Technical Service Information

NISSAN RE4FO3A SECOND GEAR STARTS

Figure 1

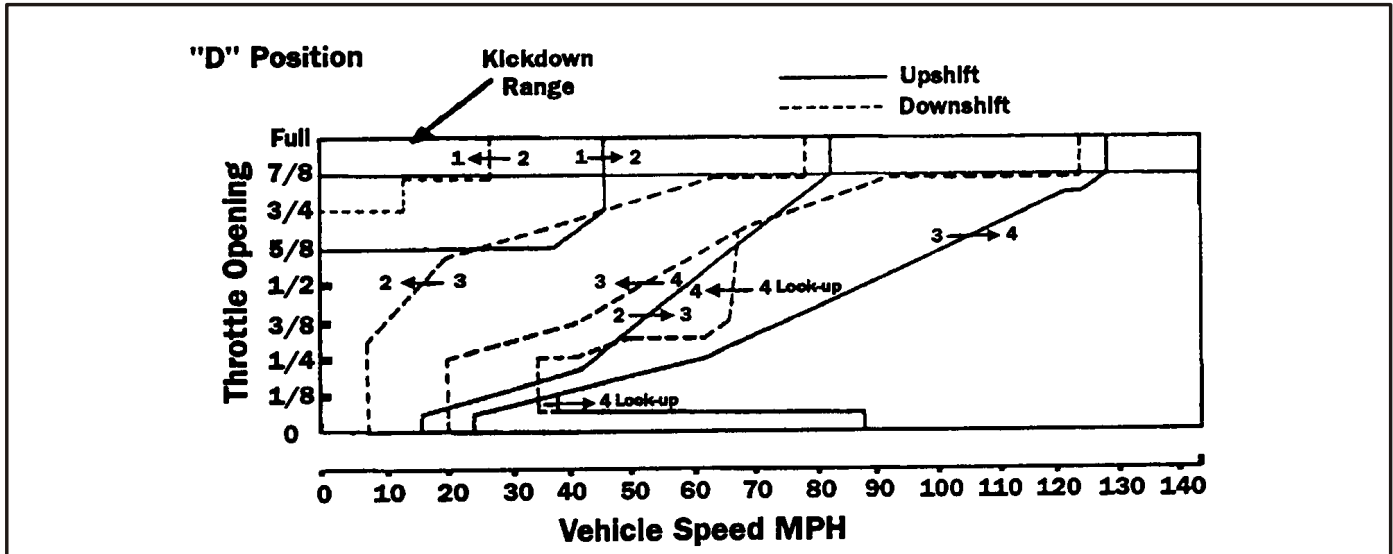
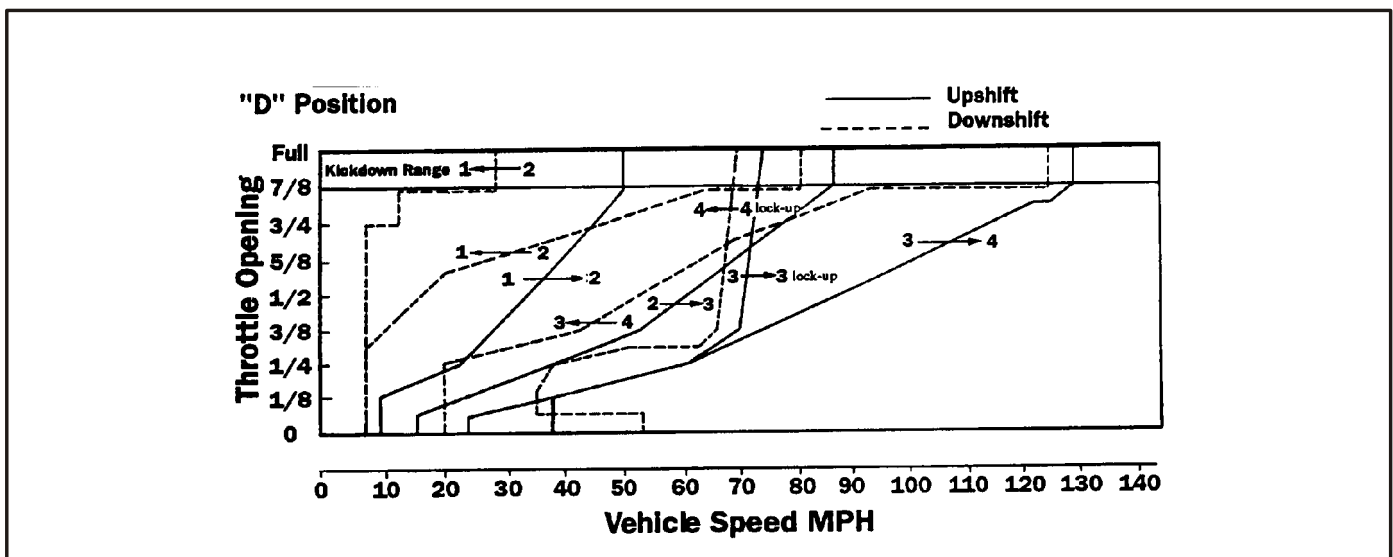
1991 -1992 Nissan Infiniti Q45 models with the RE4RO3A transmission are calibrated through the A/T Control Unit to start from a stop in second gear at less than 5/8 throttle. This is normal. The transmission will start in first gear if the throttle is opened to 5/8 or higher. The shift schedule for 1991-1992 Q45 models is shown in Figure 1.

1993 Nissan Infiniti Q45 models with the RE4RO3 A transmission are calibrated to start in first gear from a stop under all conditions. The change was made to the program in the A/T Control Unit. The shift schedule for 1993 Q45 model is shown in Figure 2.
